- **Part G Item 19 of 2AM-DOH1323, Request for Approval of Revised Waste Rock and Ore Management Plan - Responses to Party Comments**
 - **Revisions to TMAC Resources Inc. Amendment Application No. 1 of Project Certificate 003 and Water Licence 2AM-DOH1323 – Clarification on Waste Rock and Ore Management Plan**
-

Table 1 Part G Item 19 of 2AM-DOH1323, Request for Approval of Revised Waste Rock and Ore Management Plan (WR&OMP I)- Responses to Party Comments

Engineering Drawings for the Doris North Camp Area - Pad T, Doris North Project, Nunavut, Canada Water License Amendment

Doris North		
DRAWING TITLE:		
Pad T - Sections & Details		
DRAWING NO.	SHEET	REVISION NO.
DN-DMC-T3	4 OF 4	A

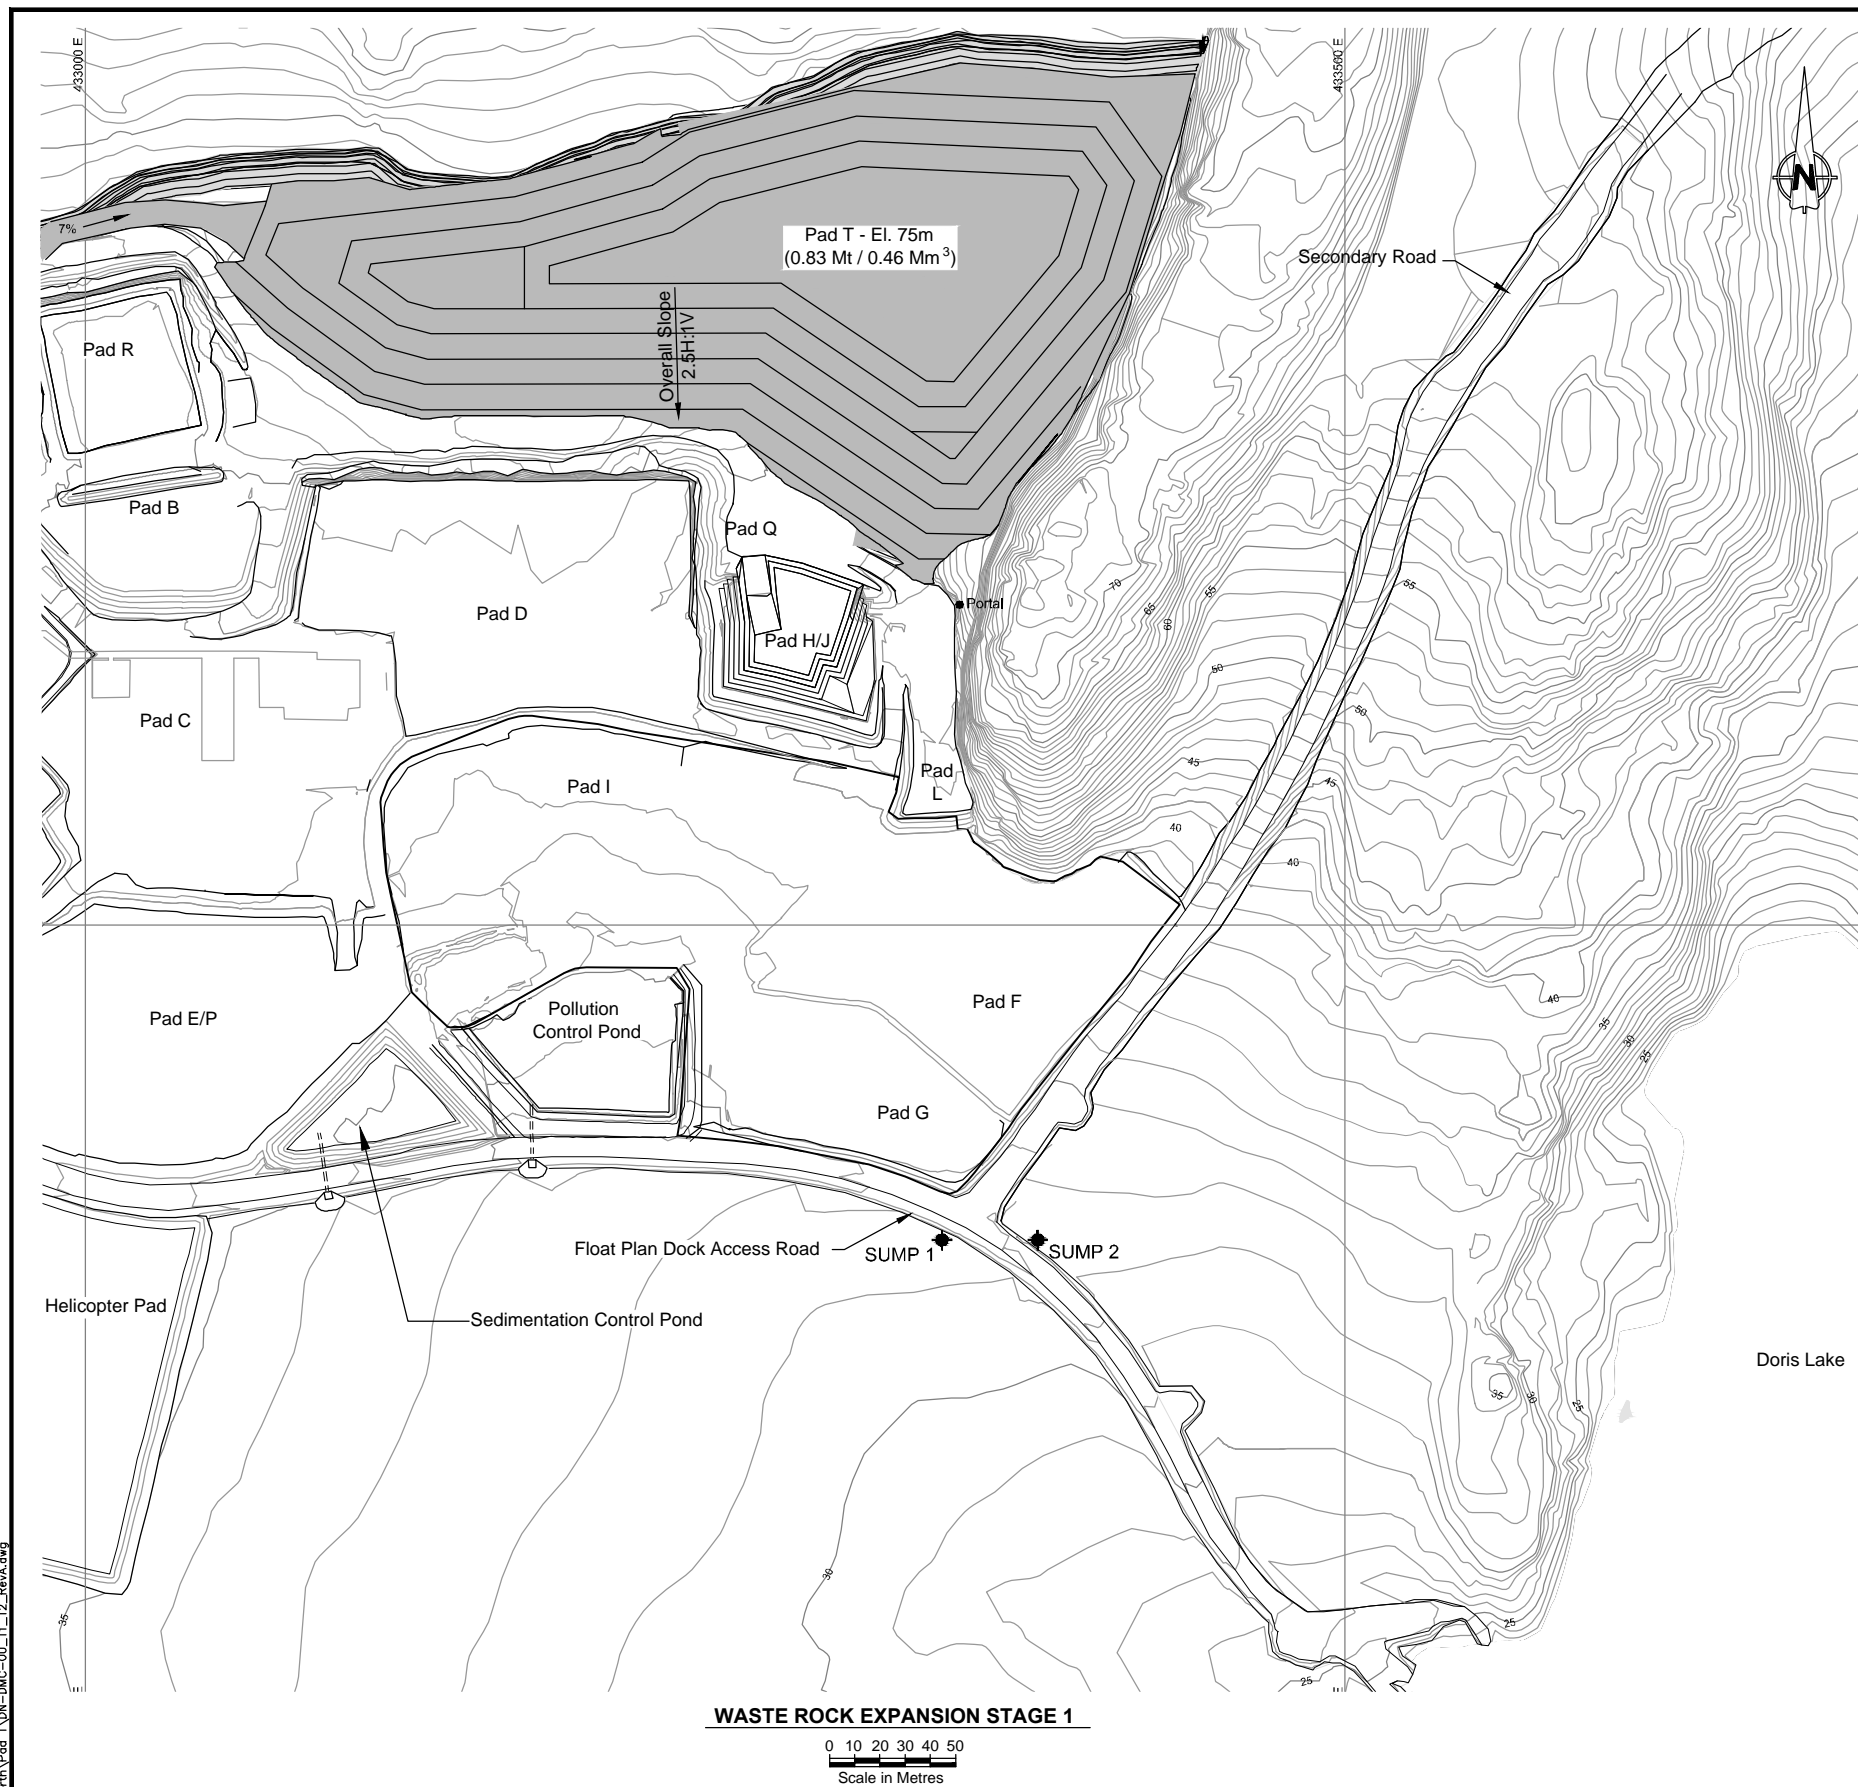
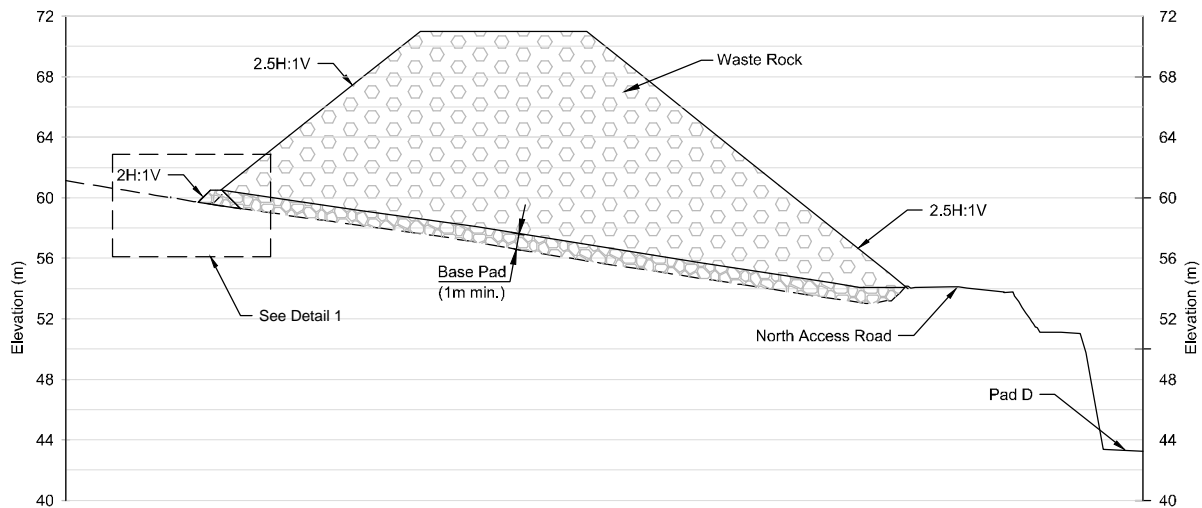
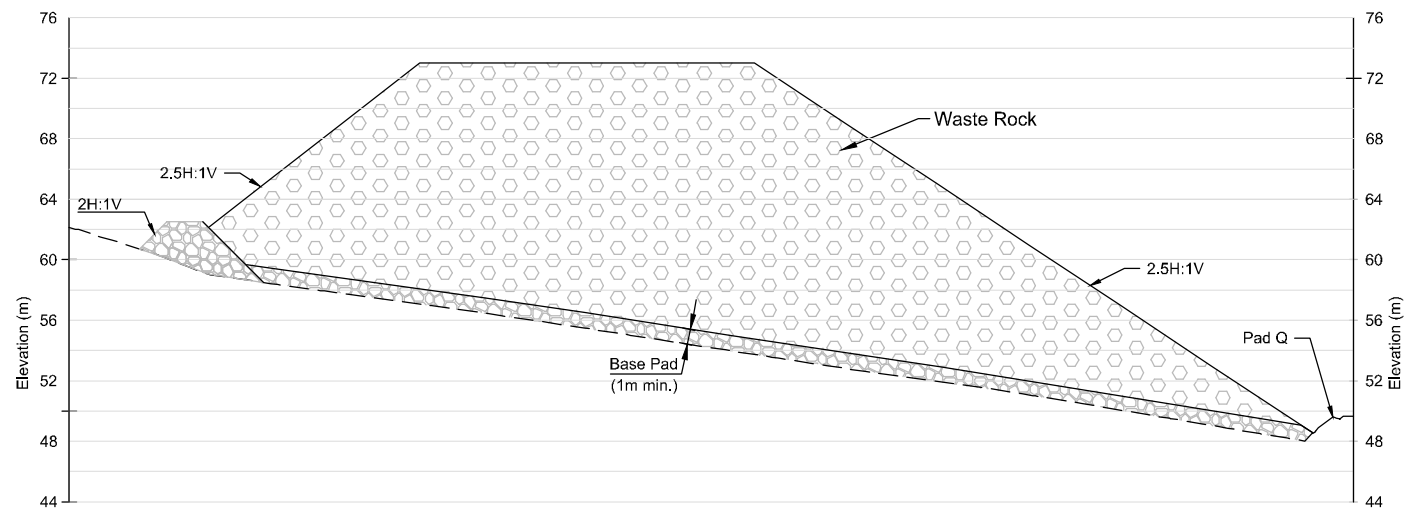
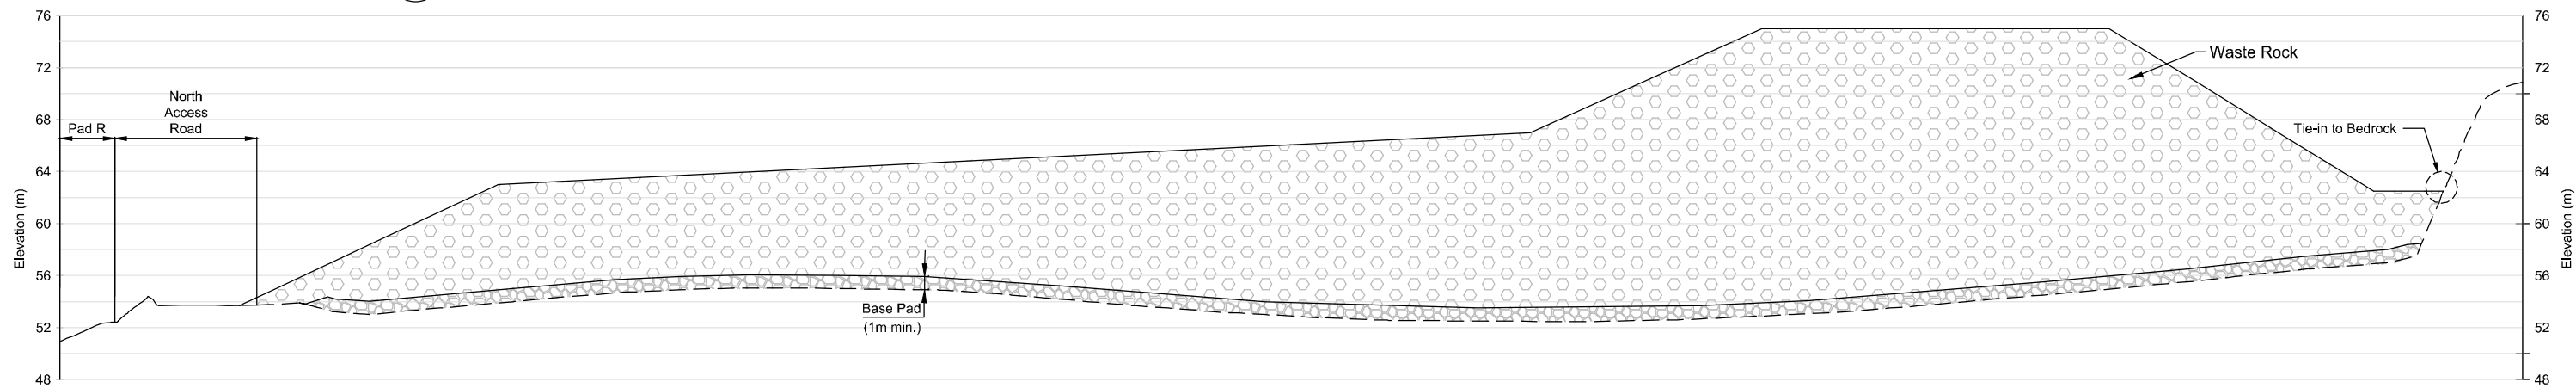
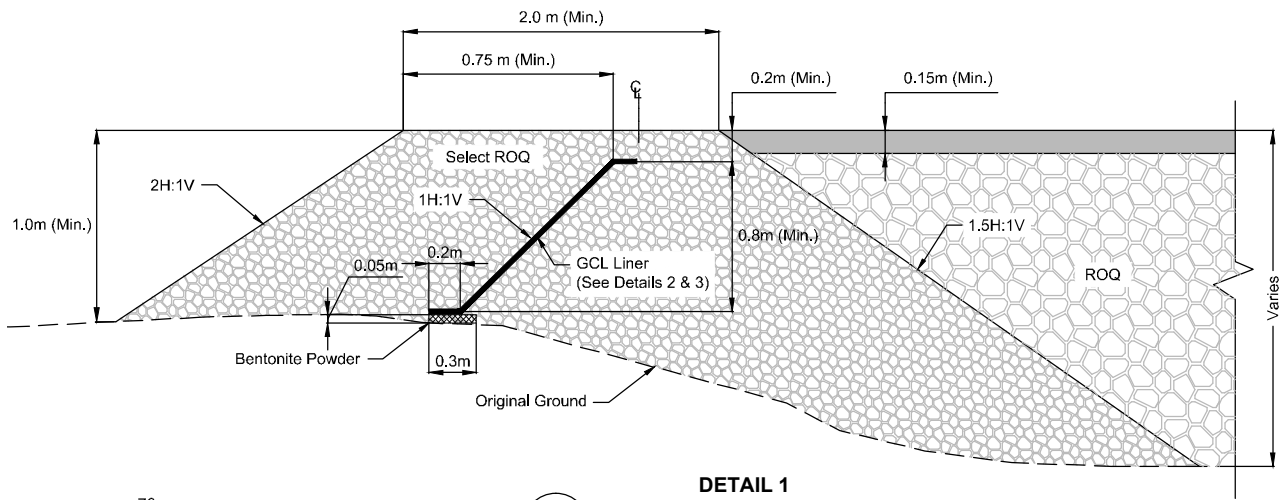
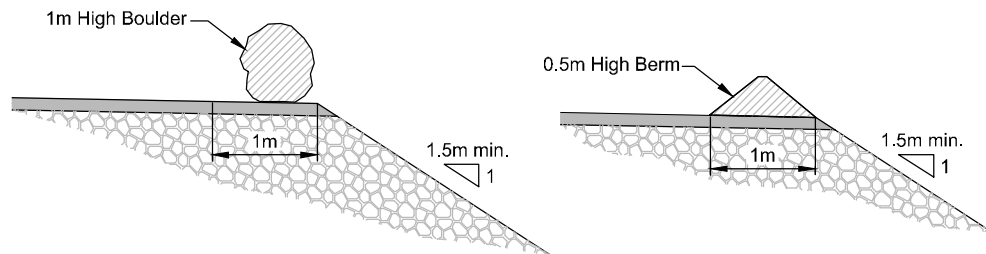
KIA June 3, 2015				
Issue #1 Stockpile Configuration				
K1	Design slope for pile	<p>Figure 3 shows 2.5H:1V on waste rock slope.</p> <p>Drawing DN-DMC-T3 shows 2.5H:1V on waste rock slope and 2H:1V on diversion berm slopes.</p>	<p>TMAC to confirm design slope for the waste rock pile.</p> <p>If 2.5H:1V is long term slope, why not construct waste dump at such slope rather than leaving possible re-sloping liability until later?</p>	<p>The long term overall slope design for the waste rock pile is 2.5H:1V.</p> <p>While it may be prudent to ensure the pile is constructed to that configuration from the outset to avoid later re-grading it should be noted that the majority of the waste rock pile on Pad T is temporary, as most of the material will ultimately be used as backfill in the mine. In addition, waste rock cannot be dumped to slopes other than angle of repose. Therefore the operational practice is to dump at angles of repose with setback benches followed by re-grading to achieve the overall design grade. This grading can either be done as dumping progresses or when all dumping has taken place.</p>

Issue #5 Drawing Details				
K5	GCL Liner	<p>Detail1 of Drawing DN-DMC-T3 Pad T – Section and Details shows GCL liner installed at 1H:1V slope.</p> <p>If GCL liner installed at 1H:1V slope, it will be very difficult to place bedding layer and properly compact over top, leading to potential stability issues on the upstream side. No information noted regarding bedding or cover layer to protect GCL. Liner would possibly be punctured without these layers leading to leakage through Diversion Berm</p>	Could there be any chance of salty water from the waste dump impacting the GCL as performance of these liners may be impacted by salt.	<p>The Doris North Camp Area Diversion Berm was constructed in 2012 as referenced on drawing DN-DMC-T3. The geosynthetic clay liner (GCL) was successfully covered and compacted and the berm has shown no signs of stability concerns as demonstrated in the two annual geotechnical inspections conducted and reported to the NWB since its construction.</p> <p>The function of the GCL liner is to divert upstream non-contact surface water runoff away from the Doris North Camp Pads. There is no chance of contact water from the waste rock pile coming into contact with the GCL liner within the Doris North Camp Diversion</p>
